Access Compliance Report

Public Rights-of-Way

Intersection ID: N/A	Main Street: E_3RD_ST	Cross Street: S_CALDWELL_ST	Location: E
ADA ID: 8715AEFE0C1C	Ramp Type: BlendTrans1	Initial Pass/Fail: Pass	Overall Compliance: No
		Severity Score: 0.25

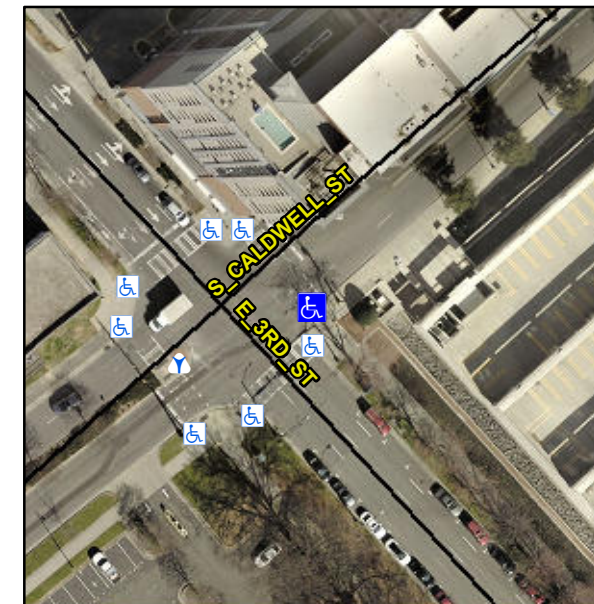
R304.5.3

Compliance	Description	Data	Compliance	Description	Data
N/A	Ramp Length (in)	77.0	Yes	BlendTrans Slope (%)	1.2
Yes	Ramp Width (in)	48.0	No	BlendTrans XSlope (%)	2.2
N/A	Flare Type LT	Sloped	N/A	Flare Type RT	Sloped
N/A	Flare Slope LT (%)	2.3	N/A	Flare Slope RT (%)	4.6
N/A	Flare Traversable LT?	No	N/A	Flare Traversable RT?	No
Yes	Landing Length (in)	84.0	Yes	DWS Provided?	Yes
Yes	Landing Width (in)	84.0	Yes	DWS Contrast?	Yes
Yes	Landing Slope (%)	0.7	Yes	DWS Length (in)	25.0
No	Landing X Slope (%)	3.2	Yes	DWS Full Width?	Yes
N/A	Landing Curb? (Y/N)	No	Yes	DWS Offset (in)	0.0
N/A	Shared Landing?	Yes			
Yes	Gutter Ponding?	No	Yes	Gutter Slope (%)	2.6
Yes	Gutter Lip Ht (in)	0.0	No	Gutter X Slope (%)	2.5
N/A	Painted X Walk1?	Yes	N/A	Painted X Walk2?	N/A
	X Walk 1 Direction	To NW		X Walk 2 Direction	N/A
	X Walk 1 Width (in)	119.0		X Walk 2 Width (in)	N/A
	X Walk 1 Slope (%)	0.5		X Walk 2 Slope (%)	N/A
	X Walk 1 X Slope (%)	1.5		X Walk 2 X Slope (%)	N/A

Yes	Ramp inside XWalk1?	Yes	N/A	Ramp inside XWalk2?	N/A
	Road Slope (%)	1.5		Clear Space?	Yes
	Road X Slope (%)	0.5	N/A	Clear Space to XWalk (in)	N/A
Yes	Any Obstructions?	No	Yes	Storm Grate/Utility Hazard?	No
	Obstruction Type			Storm Grate/Utility Type	
		N/A			N/A
			Yes	Surface Condition? (G/P)	Good
			N/A	Curb Slope (%)	4.8

Remove & Replace Curb Ramp With Two New Directional Ramps or Equivalent. Remove & Replace Gutter.
